NL-16-1169

Edwin I. Hatch Nuclear Plant Units 1 and 2
Response to Request for Additional Information on Technical Specifications
Revision Request to Implement TSTF-500, "DC Electrical Re-Write"

Response to Request for Additional Information

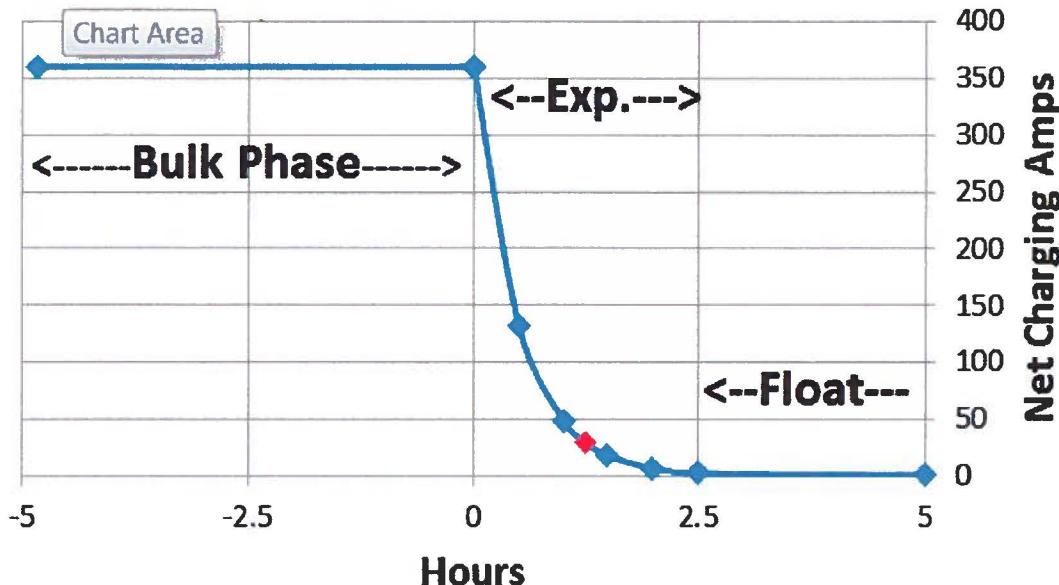
Since Conditions A and B are applicable to two different subsystems (i.e., DG and station service), please address the conditions for inoperable station service subsystems in two separate action statements, for consistency with TS 3.8.4. Please justify why two separate actions are not proposed.

SNC will modify the proposed HNP TS LCO 3.8.5 to provide two separate ACTION statements for the DG and station service batteries when the subsystem(s) are inoperable for reasons other than Conditions A or B, respectively.
